PREPARED FOR THE URBAN DESIGN COMMISSION

**Project Address:** 402-414 East Washington Avenue/8-12 N. Franklin Street/9 N. Hancock Street

**Application Type:** New Mixed-use Development (UMX Zoning) in UDD #4

**Prepared By:** Janine Glaeser, UDC Secretary

# CURRENT APPLICATION

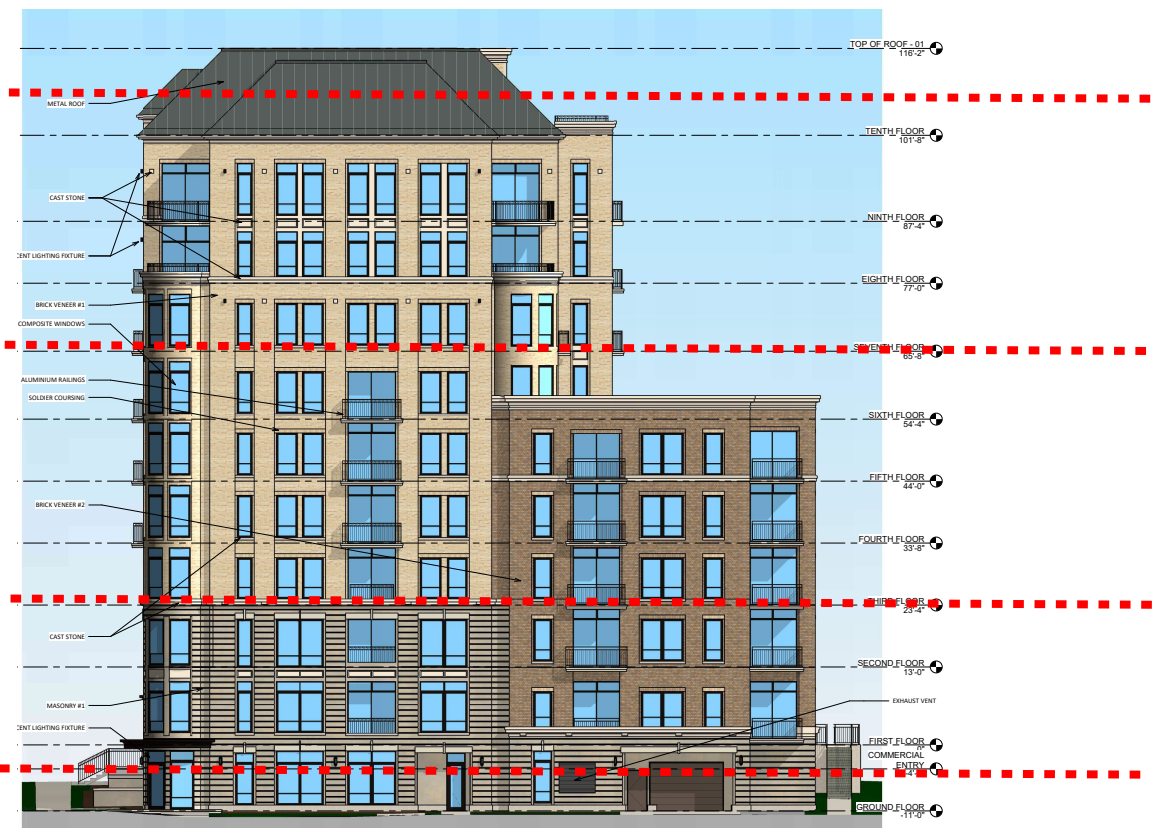
### A brief summary of some of the key design changes from the previously approved project:

- **Massing/height:** The building height has been reduced to 116' from the previously proposed 125' height. The north east corner element has been reduced to six stories at 54' height from the previously proposed seven stories at 66' height. (*see attached height diagram*) However, the building is still considered a ten-story building for zoning purposes due to the resident amenities on the level above the ninth floor (labeled as "Penthouse" (Sheet A-1.10)), which include a community room, exercise room, and pool.

- **Program:** First level commercial space has been reduced to one 1,225 square-foot space located at the southeasterly corner adjacent to N Franklin Street, with the rest of the lower levels consisting of the entry lobby and residential units. As noted above, the common space/pool/outdoor patio amenity has been moved from the lower level roof to the tenth floor. There are no residential units on the tenth floor in the current proposal.
